PLANNING CLEARANCE
 (Single Family Residential and Accessory Structures)
Community Development Department

Re: Design Exception #DE 16-04 – Design Exception – Driveway Spacing, Corner Clearance at 473 Bismarck

DESIGN EXCEPTION #DE 16-04

RE: Driveway Spacing, Corner Clearance at 473 Bismarck

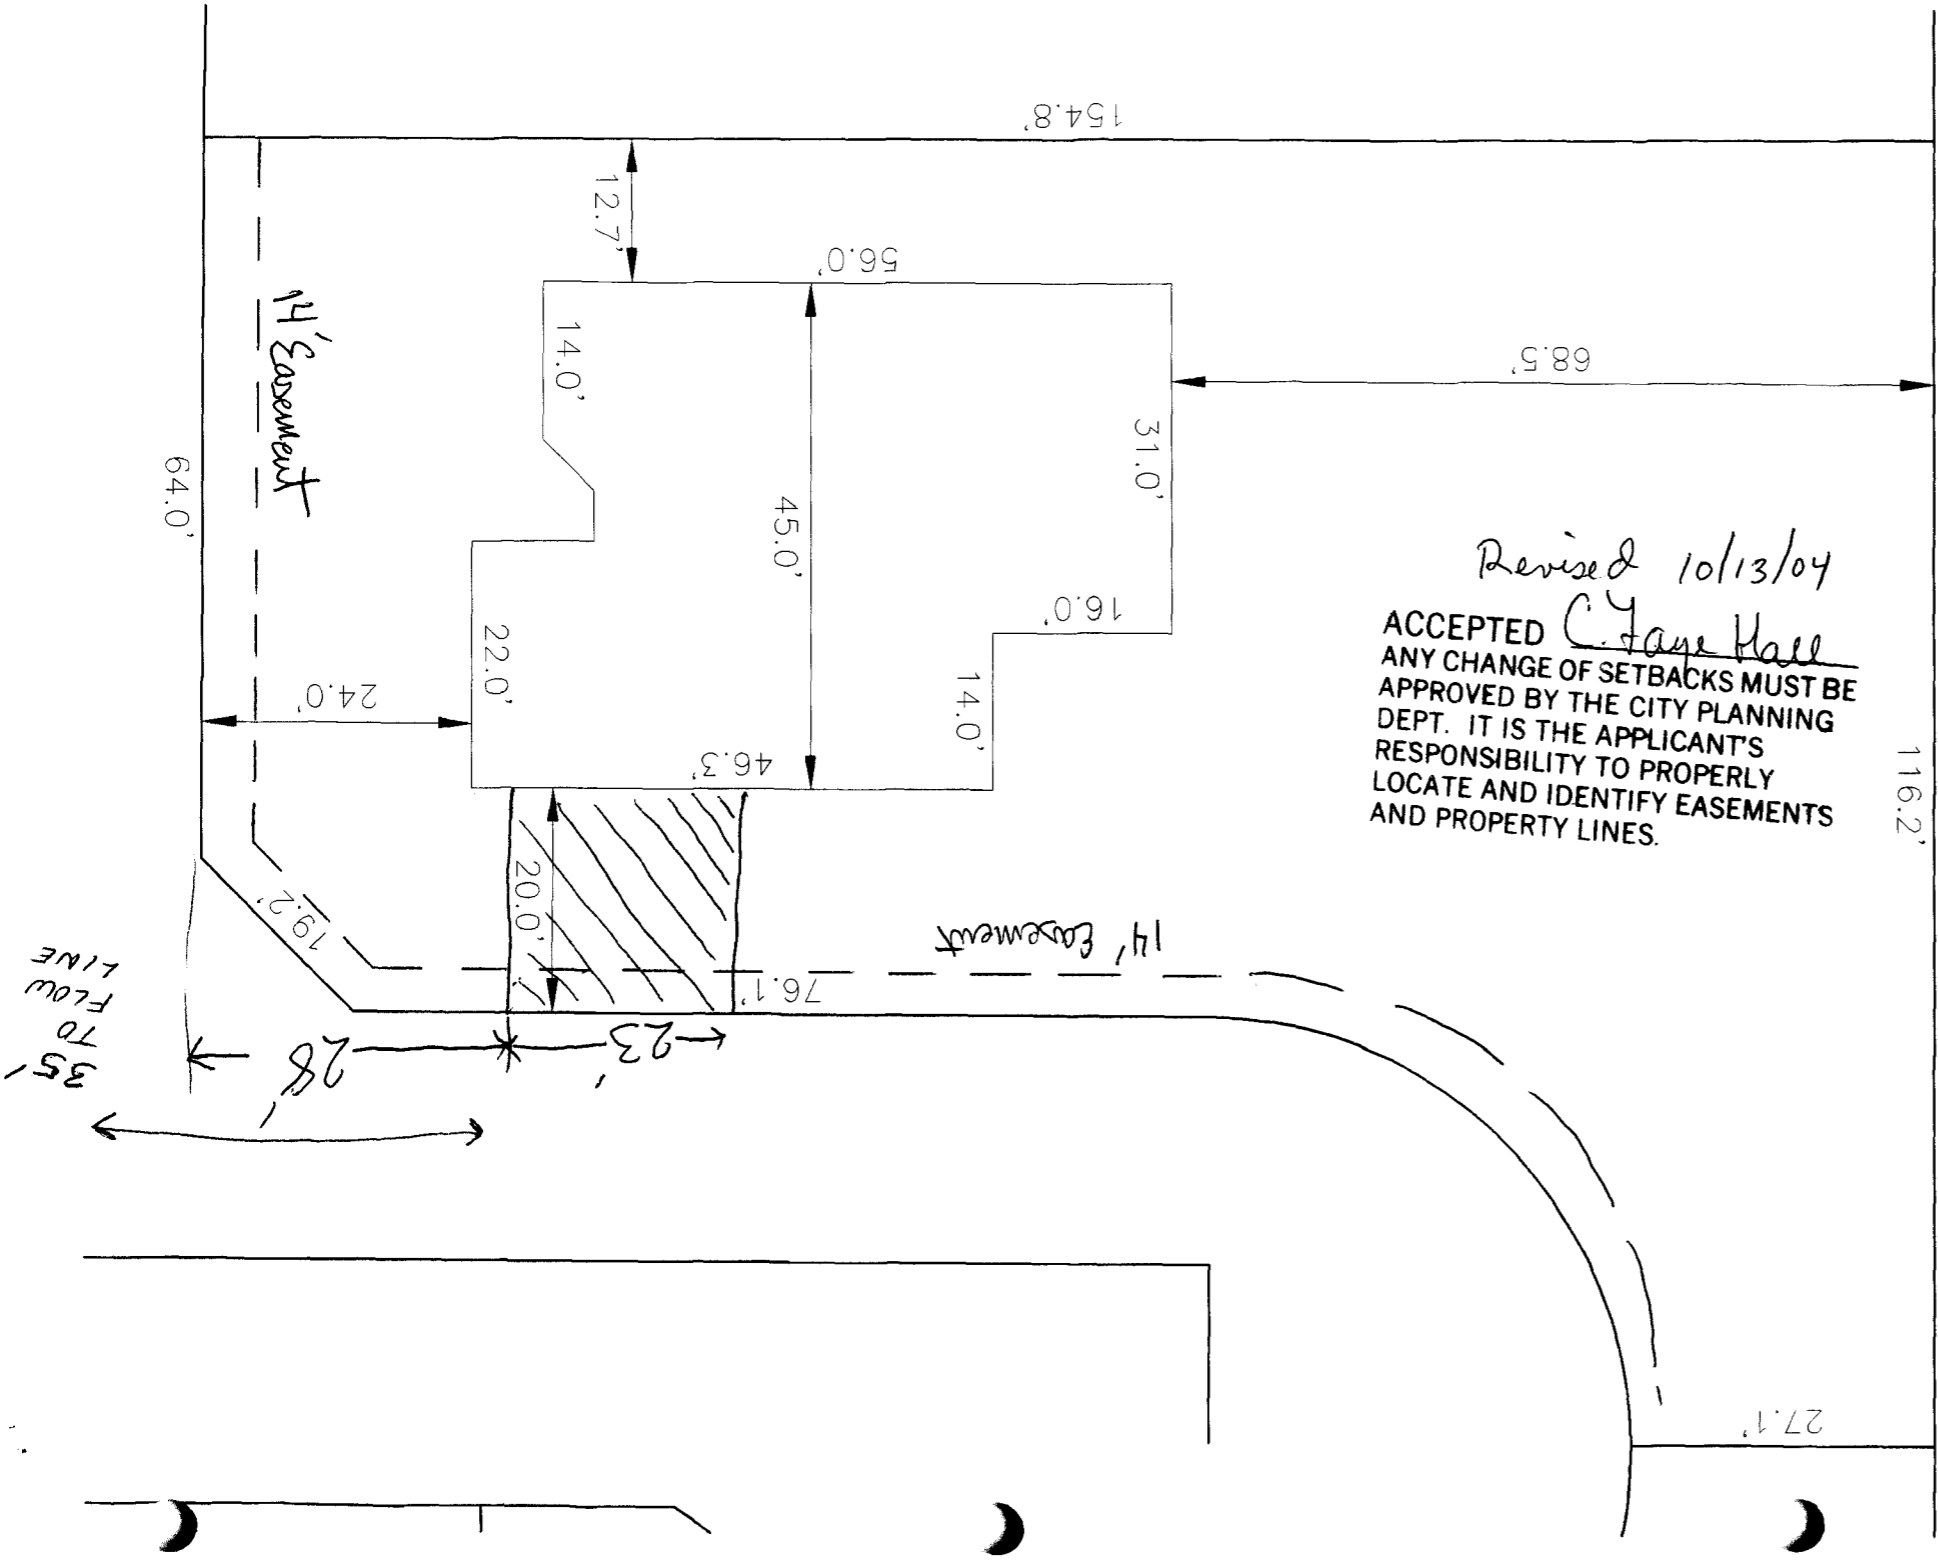
The applicant proposes to develop a corner lot in the Dakota West residential subdivide. Section 4.1.3 of TEDS requires a minimum corner clearance of 50 feet for local streets measured from the flowline to the near edge of access. Depending on the site specific plans, this distance can be difficult to obtain on smaller residential lots. Development Engineering and the Transportation Engineer have reviewed this issue and suggest that the requirement for corner clearance contained in TEDs 4.1.3 be expanded to allow for single family residential access to a local residential street to be a minimum of 35' from the intersection if (a) the street on which the access is proposed will have an ultimate ADT of 200 VPD or less, and (b) the street on which the access is proposed intersects another local residential street or residential collector

The concept of a corner clearance is to provide drivers with adequate perception-reaction time to access potential conflicts and to prevent the location of driveways within the functional area of an intersection. For very low residential streets, the potential for conflict is low. Staff believes, using the above criteria, this exception will not compromise safety.

Other alternatives include moving the building envelope away from the intersection, but creates a less desirable plan.

Staff recommends approval of this exception request.

Revised 10/13/04
 ACCEPTED *C. Jane Hall*
 ANY CHANGE OF SETBACKS MUST BE APPROVED BY THE CITY PLANNING DEPT. IT IS THE APPLICANT'S RESPONSIBILITY TO PROPERLY LOCATE AND IDENTIFY EASEMENTS AND PROPERTY LINES.
